Sandleford Park, Newbury

APP/W0340/W/20/3265460

LPA Reference: 20/01238/OUTMAJ

Wheatcroft Consultation

Figure 6 Landscape Framework Plan

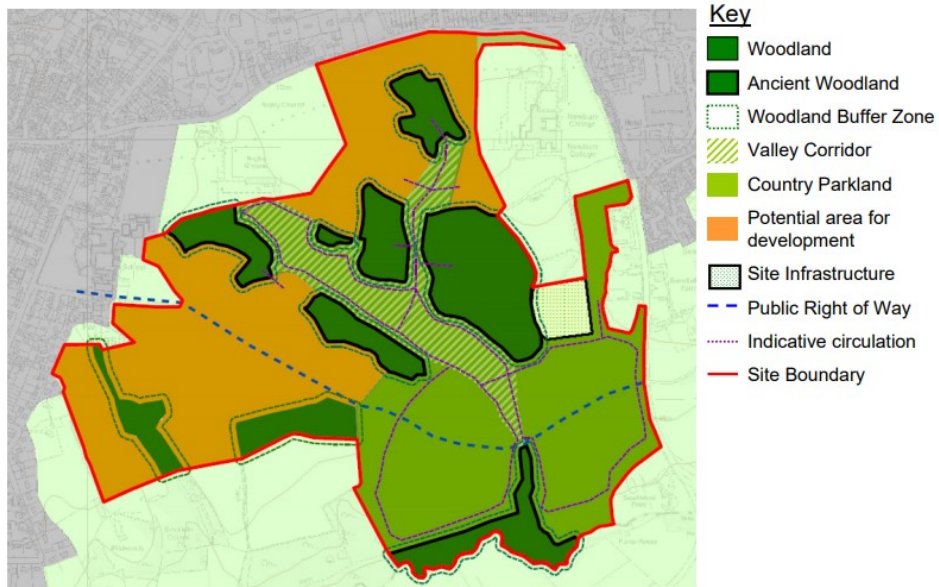
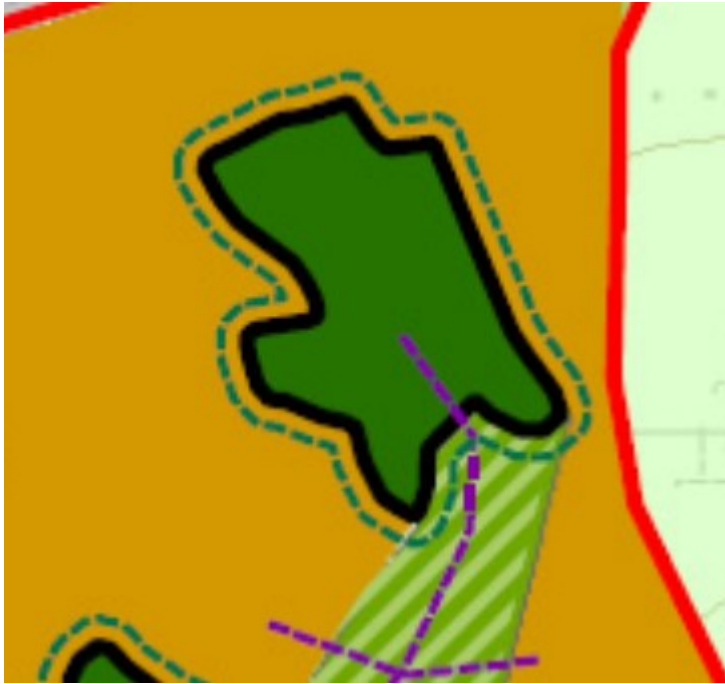
The proposed development around Crooks Copse, as shown below in Tree Protection Plan shows a significant amount of development on the south eastern side, previously I understood this section to be a children's play area?

Within the Sandford SPD Figure 6 Landscape Framework Plan, the Valley Corridor gives more green space, reducing the impact on the ancient woodland.
